Access Compliance Report

Public Rights-of-Way

Intersection ID: 26345	Main Street: BEAUCATCHER_LN	Cross Street: RHETT_BUTLER_PL	Location: NE
ADA ID: CE4210C24BA3	Ramp Type: Perp	Initial Pass/Fail: Fail	Overall Compliance: No
Severity Score: 33.75			
Codes/Mitigation Info/Possible Solution		Field Measurements/Component Compliance

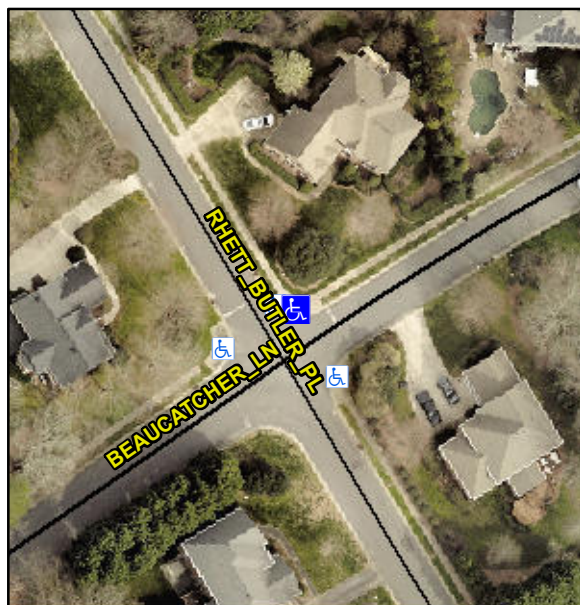
Not Found, R304.5.1, R304.5.3

Compliance	Description	Data	Compliance	Description	Data
N/A	Ramp Length (in)	50.0	Yes	Ramp Slope (%)	5.0
No	Ramp Width (in)	38.0	No	Ramp XSlope (%)	7.6
N/A	Flare Type LT	N/A	N/A	Flare Type RT	N/A
N/A	Flare Slope LT (%)	N/A	N/A	Flare Slope RT (%)	N/A
N/A	Flare Traversable LT?	N/A	N/A	Flare Traversable RT?	N/A
N/A	Landing Length (in)	N/A	N/A	DWS Provided?	N/A
N/A	Landing Width (in)	N/A	N/A	DWS Contrast?	N/A
N/A	Landing Slope (%)	N/A	N/A	DWS Length (in)	N/A
N/A	Landing X Slope (%)	N/A	N/A	DWS Full Width?	N/A
N/A	Landing Curb? (Y/N)	N/A	N/A	DWS Offset (in)	N/A
N/A	Shared Landing?	N/A			
N/A	Gutter Ponding?	N/A	N/A	Gutter Slope (%)	N/A
N/A	Gutter Lip Ht (in)	N/A	N/A	Gutter X Slope (%)	N/A
N/A	Painted X Walk1?	No	N/A	Painted X Walk2?	N/A
	X Walk 1 Direction	To S		X Walk 2 Direction	N/A
N/A	X Walk 1 Width (in)	N/A	N/A	X Walk 2 Width (in)	N/A
	X Walk 1 Slope (%)	3.6		X Walk 2 Slope (%)	N/A
	X Walk 1 X Slope (%)	4.3		X Walk 2 X Slope (%)	N/A

Remove & Replace Entire Ramp.
